Blue River Drive Design Concept

Community Comments

The following is a summary of community comments on the three design options presented at the June 24, 2023 community meeting at the McKenzie School. Staff comments are in black text; community comments are in blue text. The comments are organized as follows:

Blue River Drive Downtown: Option 1

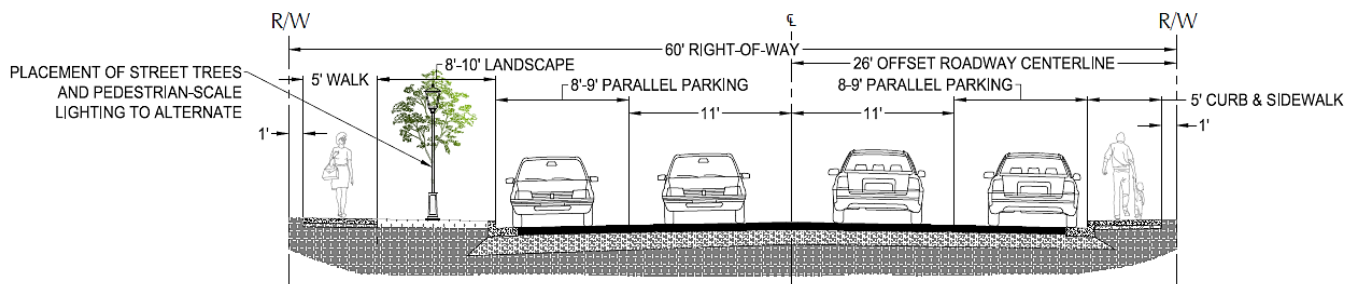
- I like the walk and trees
- Street trees, lights
- I like the 8ft.walkway, Landscape/lighting shown in option 1.
- Yes, wider walkway is good

- I believe this option is very limiting to the future of downtown. This is the worst option.
- Head-in parking could result in more damage from doors slamming into adjoining vehicles, greater difficulty for seniors or moms with children safely departing their vehicles, and increased safety with cars backing out into oncoming traffic due to line of sight blockage.

- With but one sidewalk proposed as in Options 1& 3, folks will still attempt to park parallel on the side without the sidewalk, and thus increase the hazards with moving traffic on the street and pedestrians attempting to cross, not to mention children dashing between and across.

- Both sides need parking, and both sides need a sidewalk for all business investors (and future investors) to take advantage of patronage.
- The head-in parking. It seems more dangerous than parallel parking, due to crossing lane of opposing traffic southbound, then backing into the street when leaving.

- Benches: In the past, they attract smokers and drinkers to sit there all day.
- Prefer parallel parking. Paved shoulder does not seem safe enough for cyclists.

- combine walking and biking space for 11-12 feet wide space.
- Parallel parking instead of head-in seems far less threatening if folks are sitting on benches or are biking/walking on sidewalk.

- Cars backing out onto bike lane creates a hazard. Consider a two way bike lane not in conflict with head-in parking.
- Lack of stormwater management. Consider using tree and veg strips as stormwater management system
- Don't like the head in parking where you are backing out into traffic
- To make it safer, it would have to be diagonal parking
- The library will be across the street and harried moms in minivans will need a quick way to return books on their way to the twenty-twelve errands they have to complete before dinner. And if the Christmas Supply storage space comes back as a bakery and brew pub, they'll also wish there was parking on their side of the street.

Blue River Drive Downtown: *Option 2*

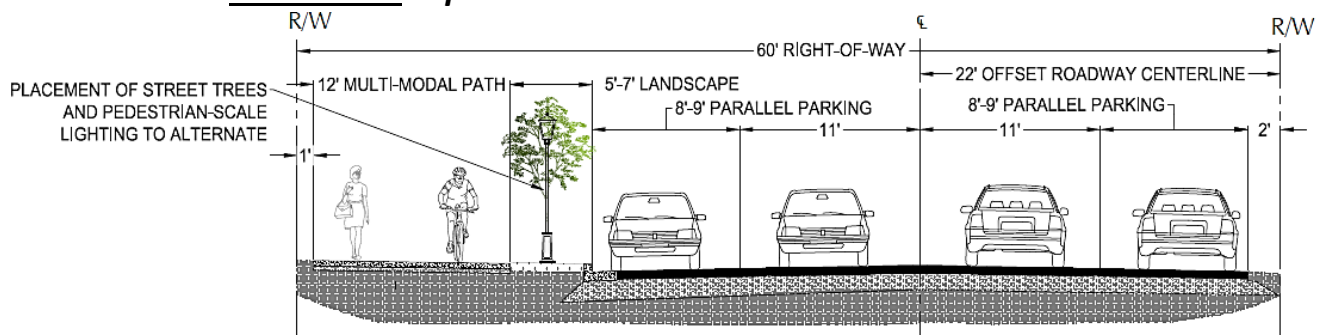
- Both sides need parking, and both sides need a sidewalk for all business investors (and future investors) to take advantage of patronage.
- Everything, really. Sidewalks on both sides of street are important, especially with the new library. Parallel parking is more pleasant-looking than head-in and less dangerous. Trees and street lights wonderful.

- I like the more traditional approach with two sidewalks. I like parking on both sides of the street as well.
- I prefer the option of parallel parking as I feel it offers a safer mode of parking downtown. Option 2 would be the alternative I favor as it offers this parking for both sides of the street as well as sidewalks on both sides. With sidewalks on each side of the street, pedestrians wishing to access businesses, residences or other buildings would have easier and safer means to get out of their vehicles, access a sidewalk that directs their traffic safely (and not in the street) and allow them to "circle" the downtown more efficiently. It might keep folks more on the perimeters and not so much crossing the street wherever. The option 2 also offers the lighting and tree features that would help define downtown as different from other roadways, adding color, shade and character.

- We would love to see a sidewalk on both sides of the street

- We are all excited to see designated sidewalks with trees and shrubs planted in a designated area to filter street run-off. I am even willing to volunteer to water a section near our property until the plants get their roots established. I have a feeling we could find other volunteers, too and I would be willing to help organize this.
- If the road did have to 'bump' out from alignment with the bridge to allocate a sidewalk on the mountain side, we think it could be a beneficial road design as we want to see infrastructure that slows the traffic down.
- I like parallel parking
- I like addressing the drainage
- I like bikes sharing the road with cars. We have a very low traffic count, not enough to need a separate bike lane.
- Parallel parking on both sides of street is good.

- The parallel situation seems to block other pre-existing driveways, I don't know how they would be able to be accessed otherwise
- I don't like the curbs
- I don't like 8'-10' for landscaping.
- Need more designated space for biking especially children.
- Consider parallel parking only on one side with bikeway on the other
- Landscaping should integrate stormwater management
- Absolutely consider stormwater management. Not just conveyance. This community cares about the river, so showing, cleaning, and cooling the stormwater is important for the health of the river and the community.
- Don't think sidewalks on both sides of the street are necessary
- No bike lane

Blue River Drive West Side: Option 1

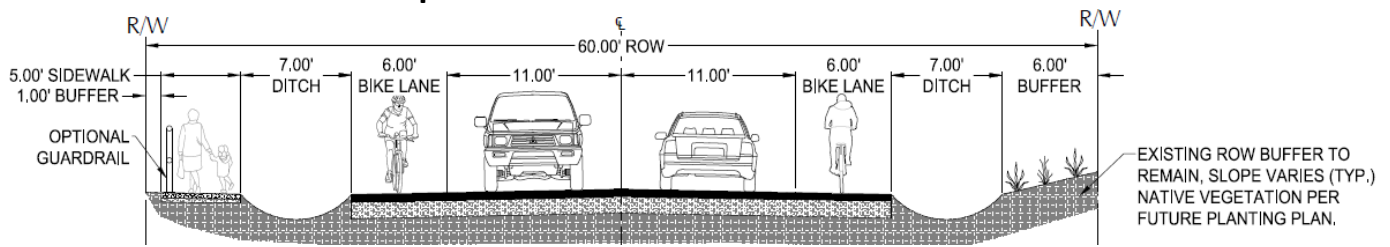
- The separate sidewalk is great.
- I like the idea of two bike lanes, with a ditch separating the pedestrians from the latter. The wider pedestrian area, may I suggest, possibly accommodate both, a 5 ft. hard surface sidewalk and maybe a 3 ft. "soft" running trail that would eventually loop into a running trail/sidewalk on the South side of Three Sisters Meadow and the Track. This would offer a literal loop for both walkers and joggers, approximately 3 miles long, connecting Blue River and the School, Track, and other future trail systems originating in Blue River.
- I like pedestrians having a space but think it could blend with Bikes to accommodate the low traffic count we have now.
- This looks good! I like the ditches that give more safe space for pedestrians on the sidewalk and like the wide 8' sidewalk.
- Yes, ditch for water runoff.
- Bike lanes on both sides of road

- I do not like the 6' ditch or 9' buffer.
- Combine sidewalks and bike lanes for a 12 foot wide space
- Sidewalks on both sides of the street seems more important than the 12' path on only one side. Library seems like it needs a sidewalk on that side of the street.
- Recommend combining safe sidewalks and biking to allow for more buffers and stormwater management
- Ditch only on one side
- Nice if sidewalk was soft surface

Blue River Drive West Side: Option 2

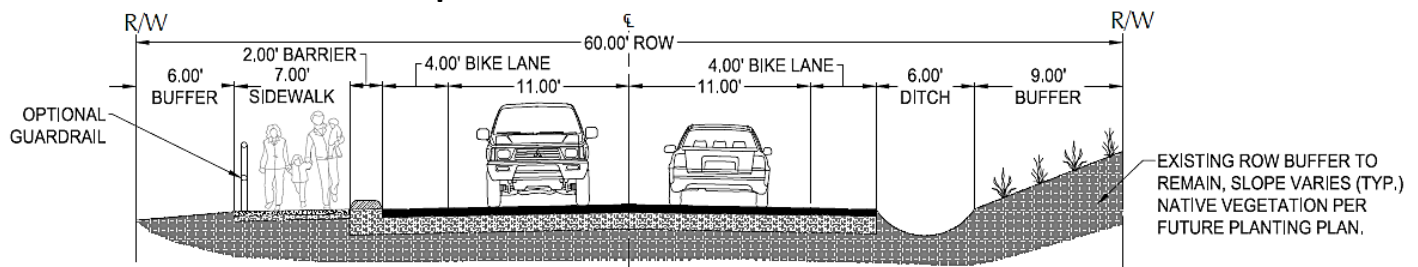
- The bike lanes are nice.
- The narrower sidewalk than option 3
- Would be nice if sidewalk was able to be soft surface
- Like the 6' bike lane

- Sidewalk seems too narrow
- I don't like the ditch option or buffers or the guard rail
- I don't think the number of bikes in the neighborhood need a separate bike lane. They can share with cars.
- Ditches only one side of the road
- Combine 5 foot walkway on south side of street with 6 foot wide bike lane, if possible
- Is bike lane needed on both sides of street? What about combining them on the south side of the street for an 11 foot width?
- Recommend combining safe sidewalks and biking to allow for more buffers and stormwater management
- Ditches and bike lanes are too wide
